Alston Licence Renewals: Alston Plumsgate Road AN/34/0009/008 and Alston Ludham Road AN/34/0009/009.

Response to the Broads Authority on Concerns Relating to the Groundwater Investigations and Modelling Work

1. Overview

Figure 2. Simulated responses at TG32/805 (near Alston Ludham Road)

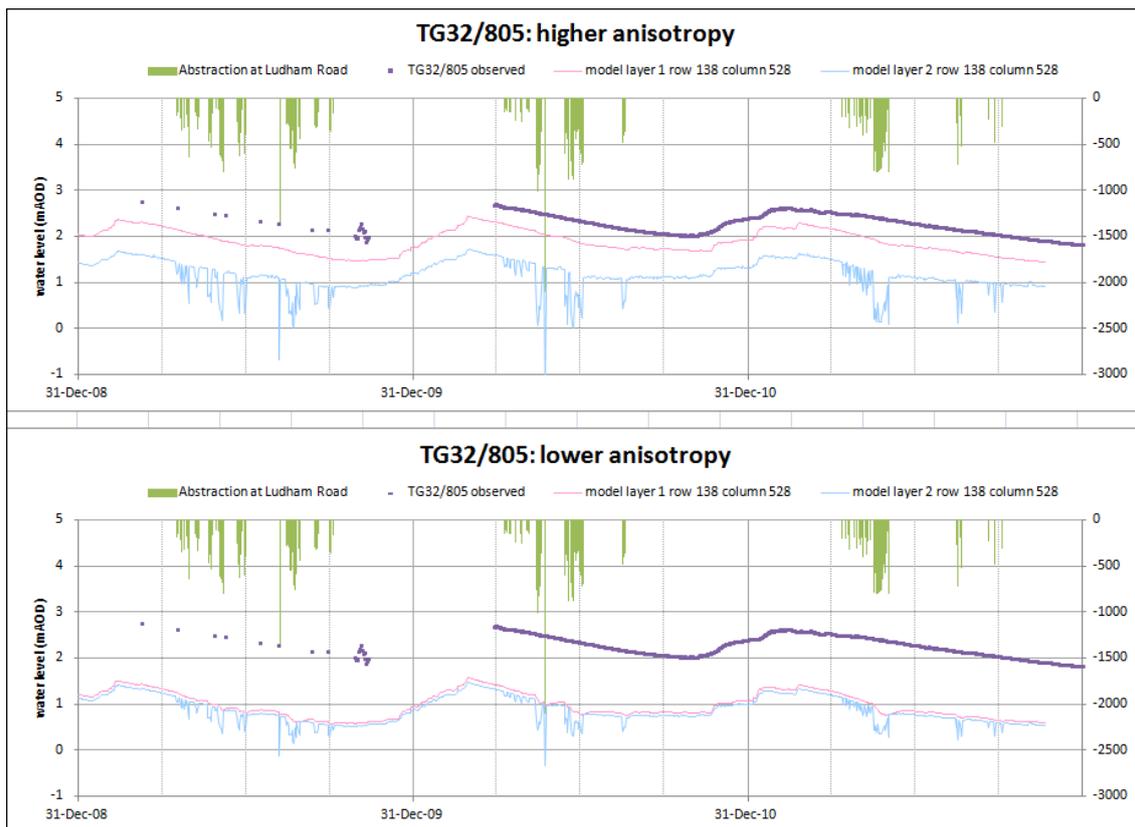
Results from the radial model were used to inform the regional model. Up until the radial modelling was done, simulations with the regional model had used Crag anisotropy values of 10 or 100, but had not been successful in reproducing some of the observed features of water level responses to abstraction. This applied throughout the area of interest, with signals from abstractions at AWS Ludham, Alston Ludham Road and Alston Plumsgate Road not being well reproduced by the model.

Introduction of the higher anisotropy value (i.e. of 1000) supported by the radial analysis improved the simulation of abstraction signals considerably. Figure 1 illustrates improved responses at the Sharp Street piezometers (affected by AWS Ludham), at boreholes TG32/801 and 805 (affected by Alston Ludham Road), and at the two piezometers at different depths near Plumsgate Road.

Figures 2 and 3 show observed and simulated water levels at two locations not far from the Alston Ludham Road abstraction. TG32/805, Figure 2 is very close to the Alston Ludham Road and is believed to respond to changes in the upper part of the Crag; little response to abstraction is seen here, whereas an observation location further away (TG32/801, Figure 3), believed to respond to changes in the middle part of the Crag, shows some subtle response to the abstraction in summer months. This is most clearly seen in May and June 2010, and in May and August 2011. This was difficult to understand until anisotropy was considered. At TG32/805, both the high and low anisotropy simulations show clear responses in the middle part of the Crag (model layer 2) to the seasonal abstraction, but the low anisotropy model shows a response to these abstraction events (albeit small) in the upper part of the Crag as well, i.e. contrary to the observations, whereas the high anisotropy model shows virtually no response. At TG32/801, the low anisotropy model shows virtually no response, which is also contrary to observations, whereas the high anisotropy model simulates the observed signal well. This suggests that the high anisotropy model is applicable.

Figure 16. Observed and simulated water levels at TG32/617b

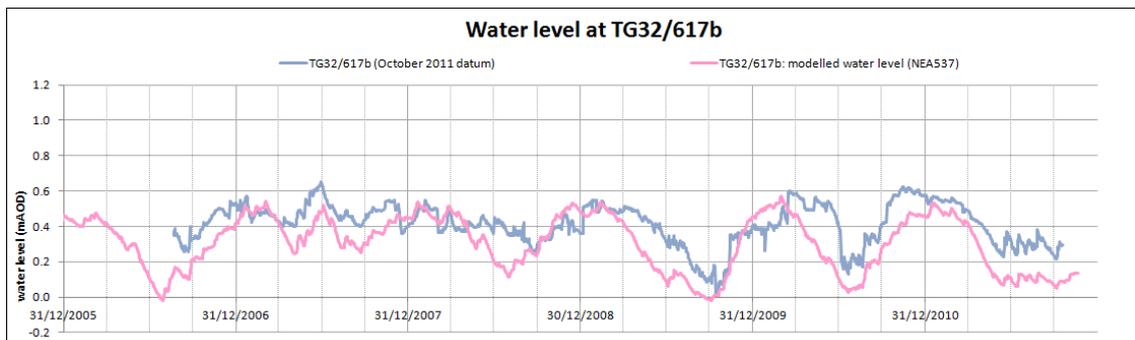
The current model configuration provides a good simulation of observed water levels. However, commenting on Figure 7.2 of the Summary Report, Professor Rushton has noted that “*the general form of the fluctuations for field and computational model are roughly similar, but for certain periods there are significant differences with the modelled fluctuations substantially larger than those observed in the field*”. Whether the fluctuations are substantially larger is a matter of opinion, but there are some small differences in the character of the time series between observed and modelled. Perhaps the most noticeable is the difference in recession in some years: the model recession happens too early, although the trough is at about the right level. This is not seen in 2007, perhaps related to the wet summer.

At this location, the elevation of the stream boundary condition is 0.35m. Professor Rushton has noted that “for each stream cell a surface water elevation is imposed, with the result that the groundwater head in Layer 1 cannot be very different from the enforced water elevation”. It is

Only data up to early 2010 were used for comparison with simulated levels at the time of model development, and these data were presented in Figure 7.2 of the Summary Report and Figure 7.13b of the Main Report. Figure 16 show additional data covering the full modelled period. The model ‘fit’ for 2010 and 2011 is similar to the earlier period, i.e. the model recession occurs earlier than observed. The simulated troughs are slightly lower than observed for 2010 and 2011, although the unusual fluctuating ‘shape’ in mid-2011 is reproduced.

clear from the above graph that the modelled water levels are not ‘clamped’ at this elevation, and respond realistically both above and below this elevation.
